Proposed Revisions to a Standard Plans Index

Index Number: 676-010
Sheet Number (s): 4 of 4
Index Title: Cabinet Installation Details

Summary of the changes:

GROUND MOUNTED CONTROLLER CABINET RISER

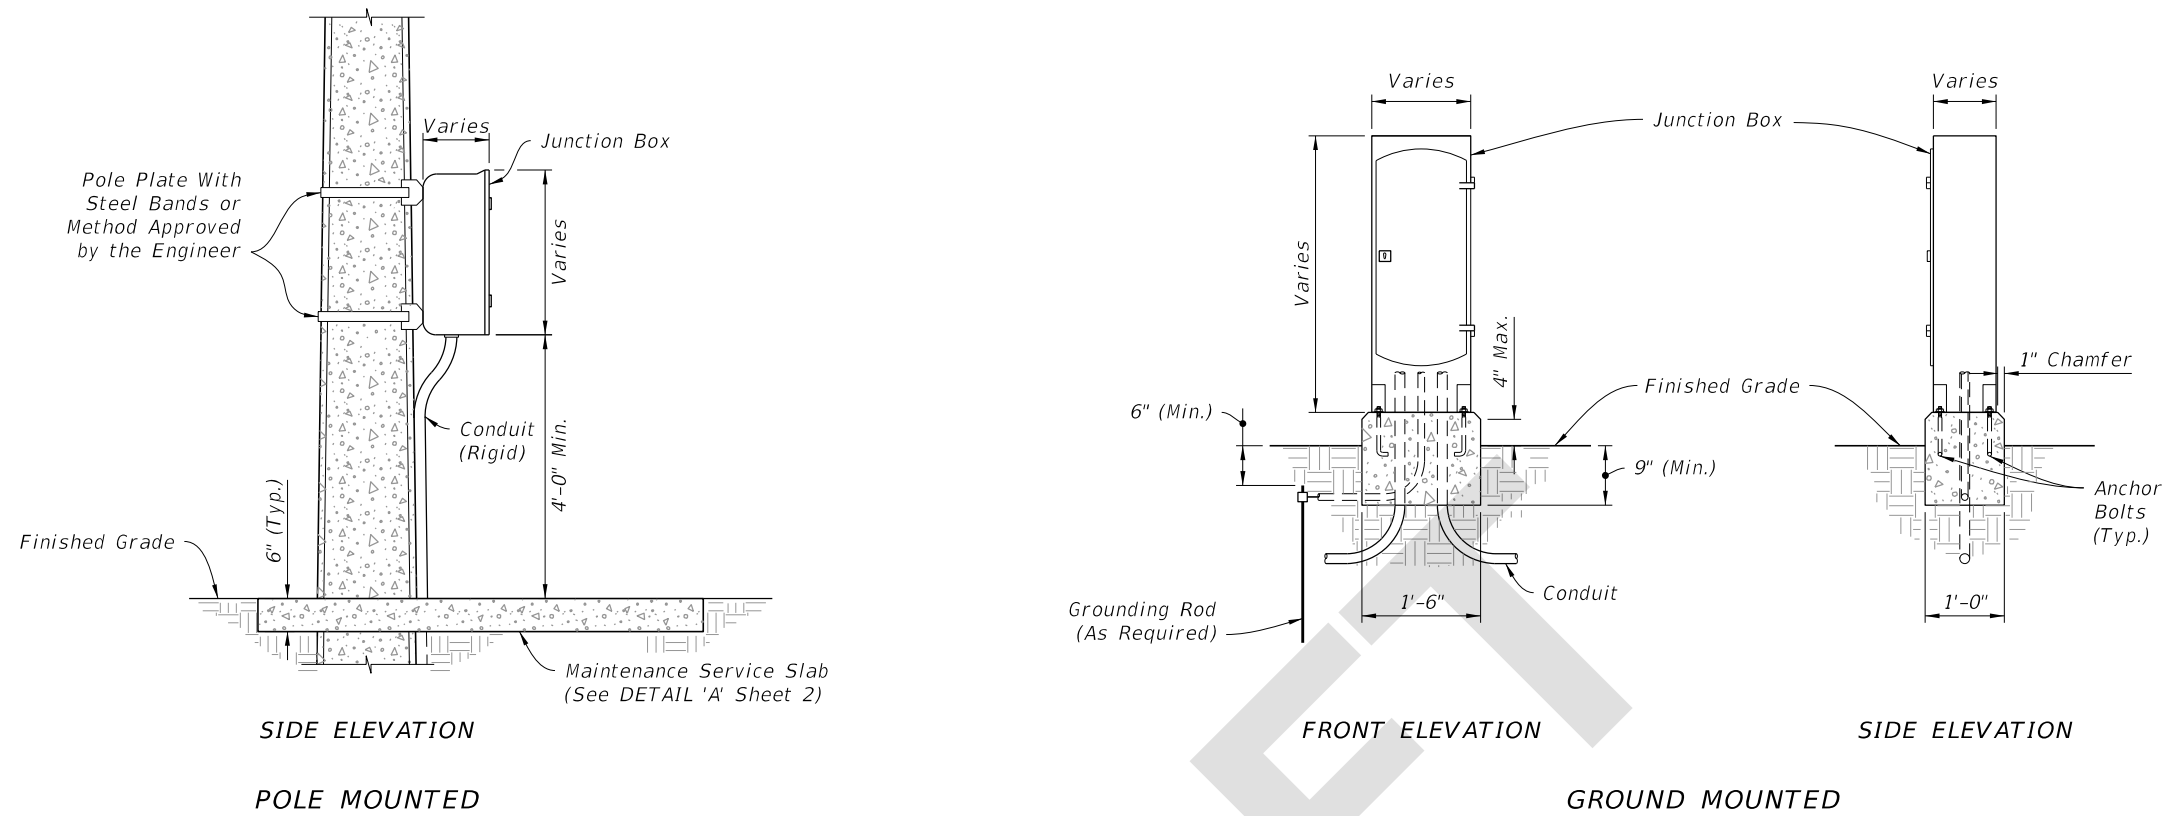
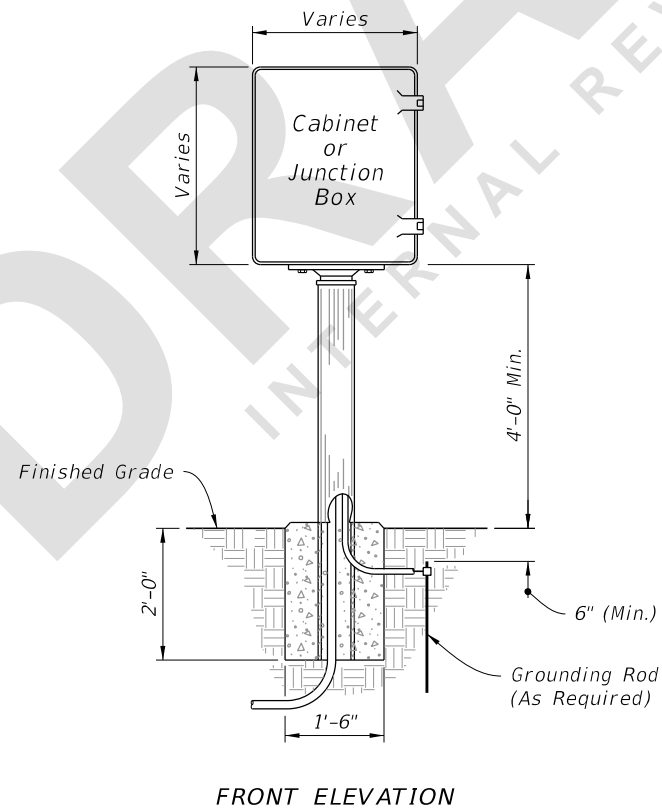
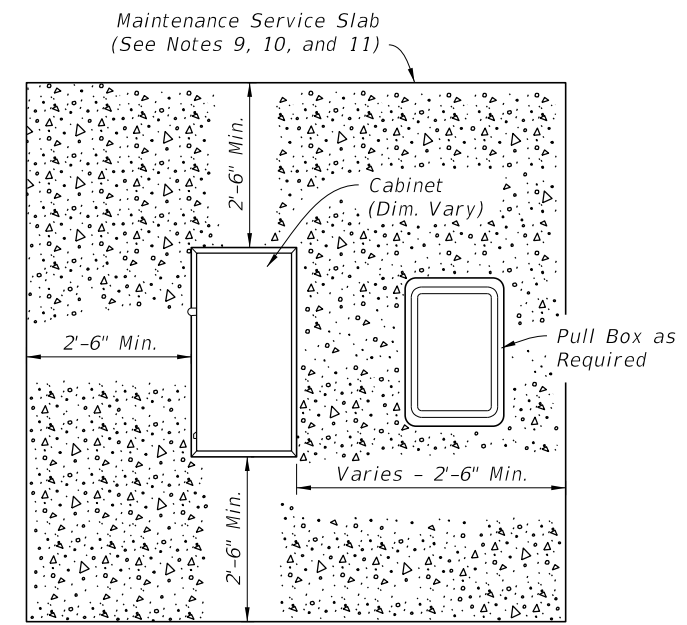
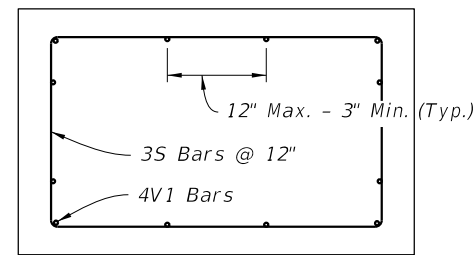
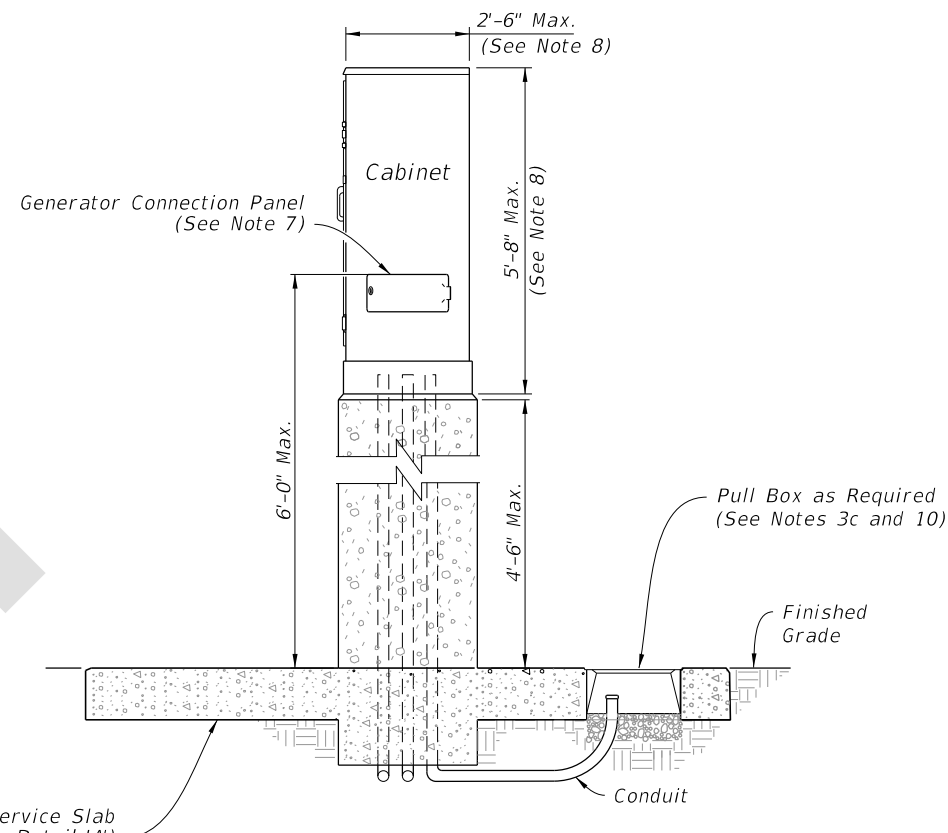
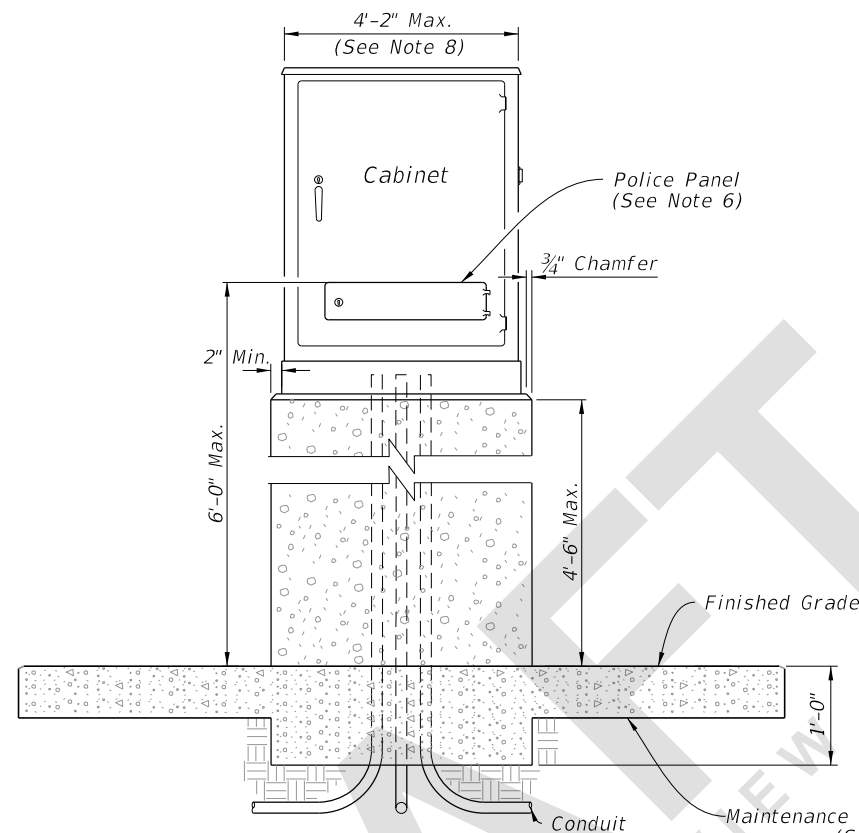
Sheet 4: New Sheet for Ground Mounted Controller Cabinet Riser

This request came from the Districts and was coordinated with the TERL and Structures Design. Some Districts are installing these and the addition to the Standard Plans Index will allow use without a special detail in every plan set. This detail is for a concrete riser only. An associated change is being made to Specification 676 regarding this revision.

1. Install cabinet riser as called for in the Plans. Concrete riser shown, for other options, see Specification 676.
2. Concrete:
 - a. Concrete will be in accordance with Specification 346.

- b. Concrete will be Class IV.
3. Reinforcing:
 - a. Reinforcing will be in accordance with Specification 415.
 - b. All reinforcing steel will have a 2" minimum cover unless noted otherwise.

- c. Adjust reinforcing to facilitate Pull Box. Add equal number of bars to either side for each bar interrupted by Pull Box.
4. Generator connection cables will be extended by the same length as the riser's height.

5. Locate door vent at rear door of cabinet assembly.
6. Locate Police Panel at bottom of cabinet assembly.
7. Locate generator connection panel at bottom of cabinet assembly.

8. Riser dimensions shown are based on maximum cabinet dimensions per the APL.
9. Slope maintenance slab 1/4" to 1" for drainage. Not required in sidewalk, pavement areas, or where R/W is restricted.
